PROJECT:
PROPOSED COFFEE SHOP
STRUTHERS RD.
COLORADO SPRINGS, CO

SHEET TITLE:
LANDSCAPE PLAN

COUNTY PROJECT NUMBER PPR-17-030

SHEET TITLE:
LANDSCAPE NOTES AND DETAILS

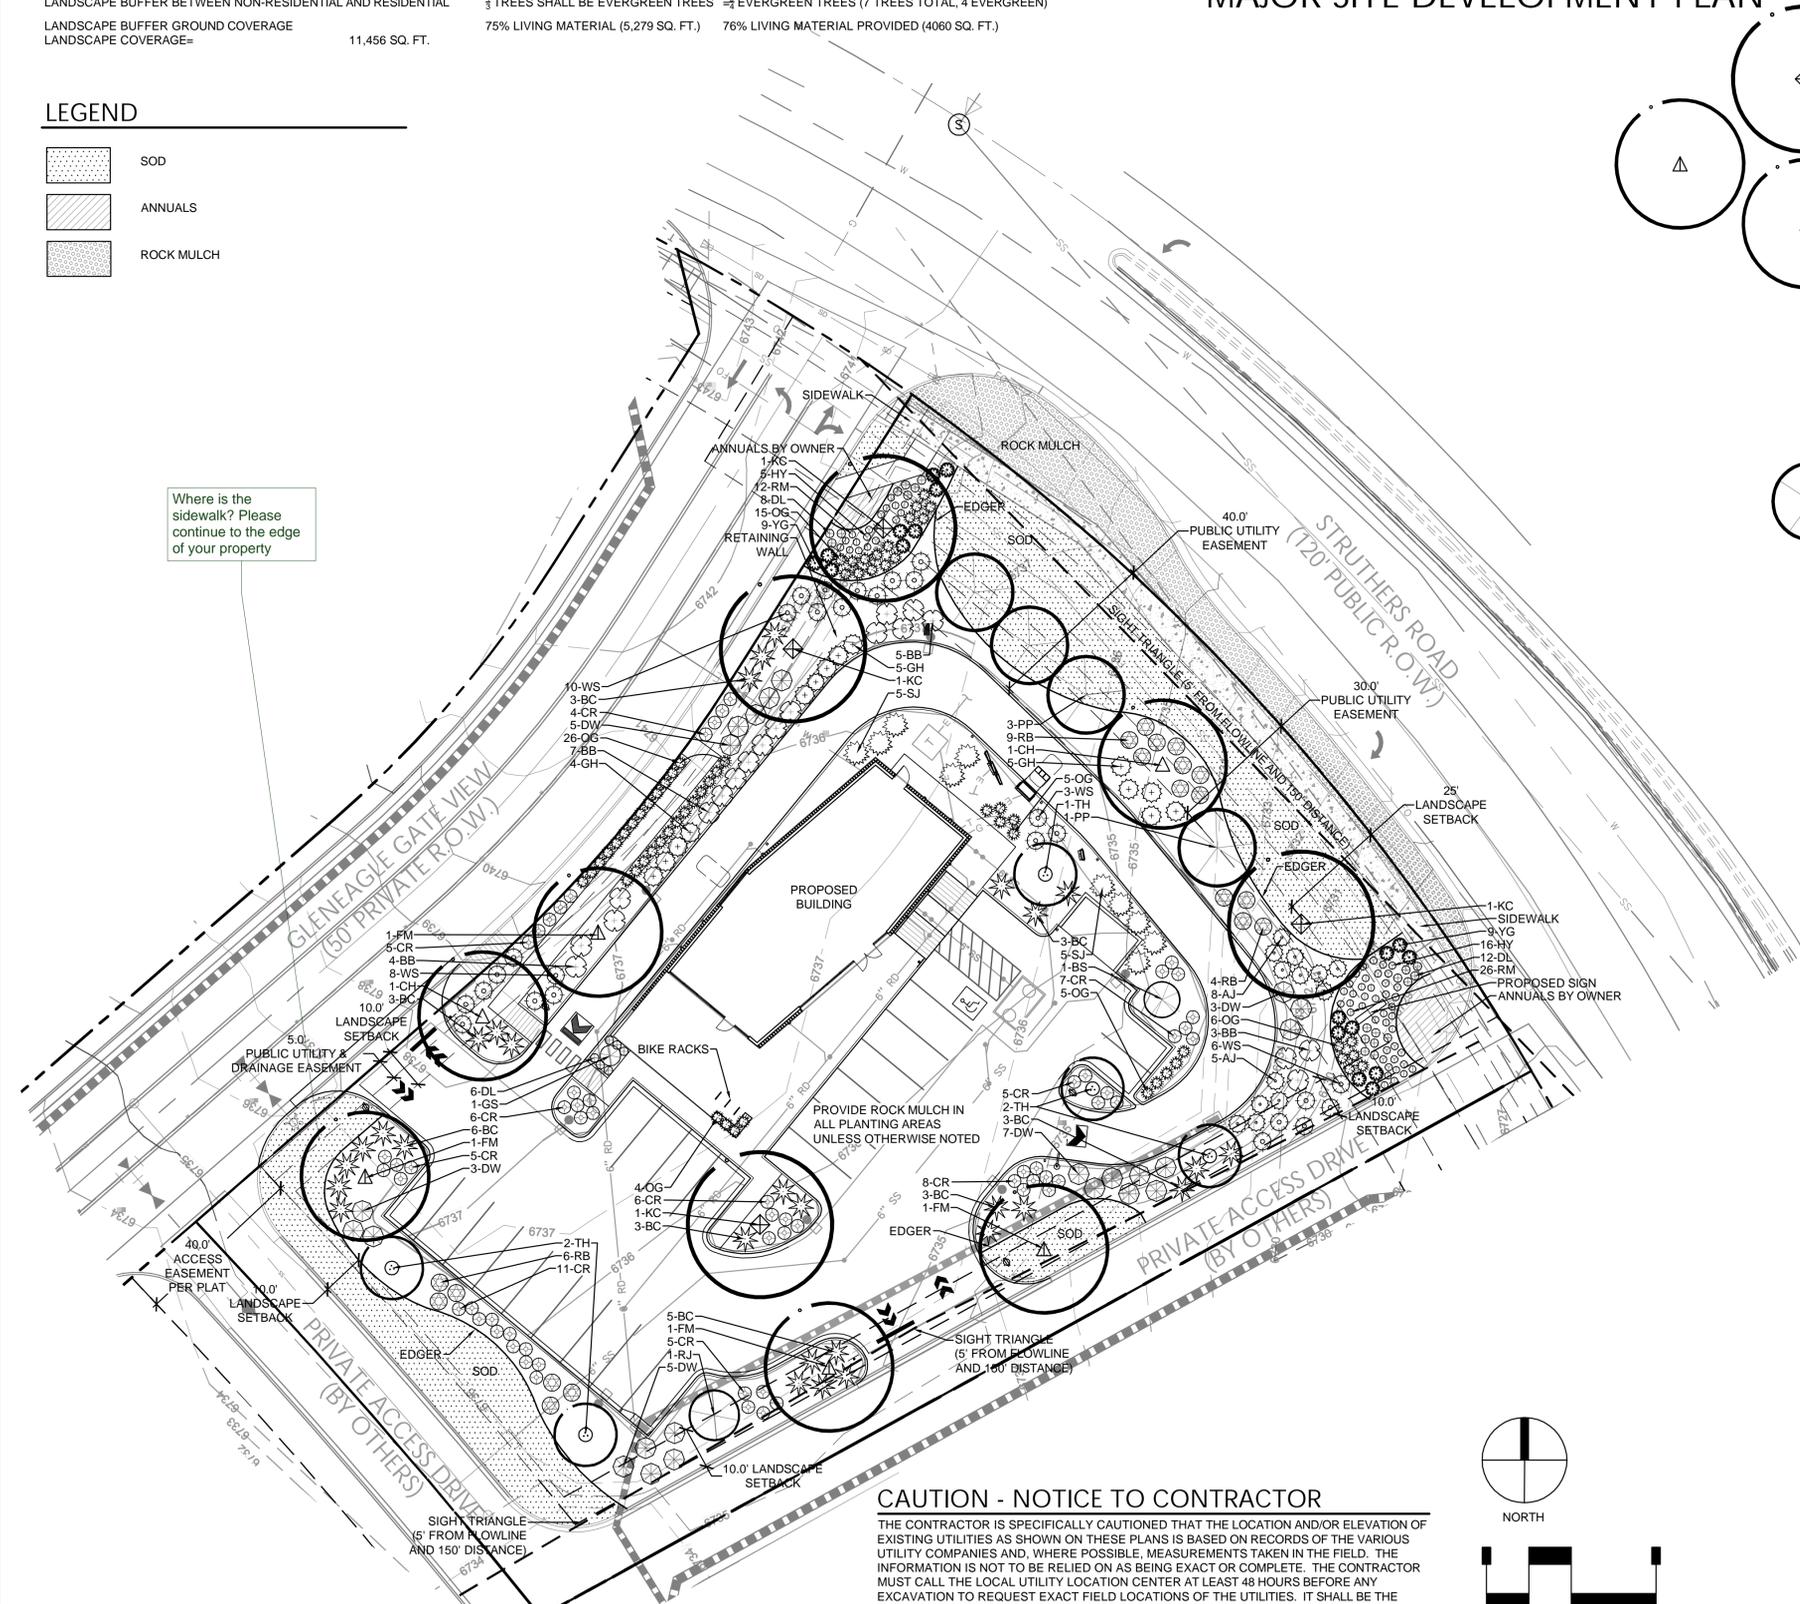
Where is the sidewalk? Please continue to the edge of your property

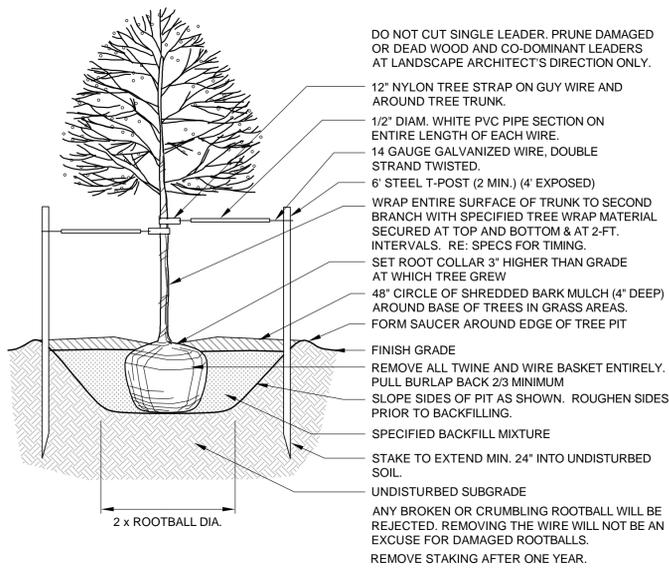
Please provide a detail of the trash enclosure. See page 6-12.
